SERVICE BULLETIN

Classification:	Reference:	Date:
AT10-006	NTB11-011	February 18, 2011

2009 - 2011 GT-R MIL "ON" WITH DTC P0729/P2832 STORED

APPLIED VEHICLE: 2009 – 2011 GT-R (R35)

Figure 13

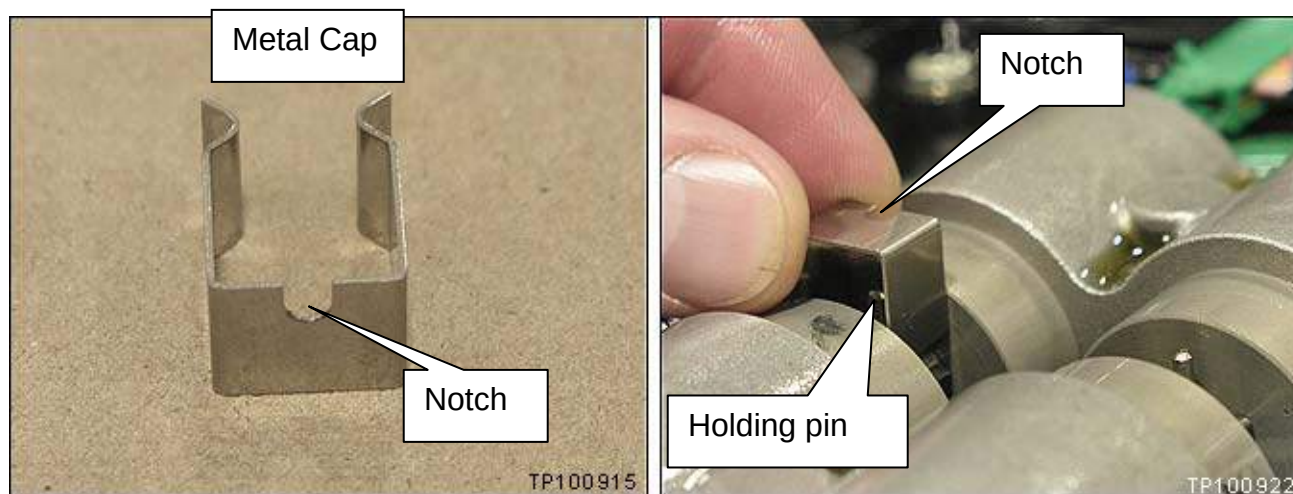
15. Install a Metal Cap onto 3 of the ACM shift pistons.

- Make sure the notch is aligned with the retaining pins.

Figure 14

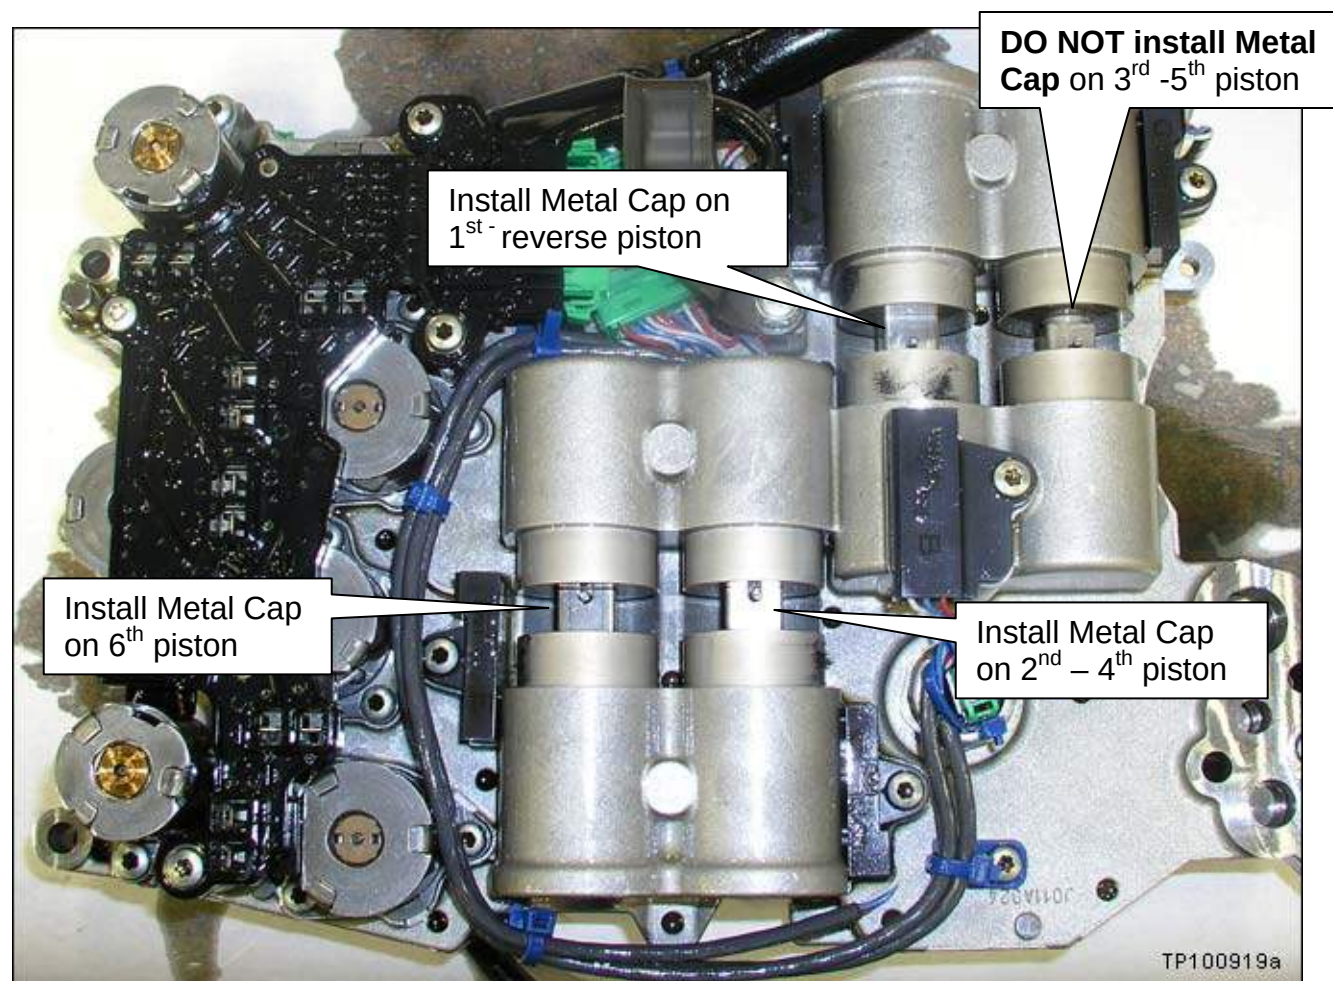
- Install Metal Caps on the 3 pistons shown in Figure 14.
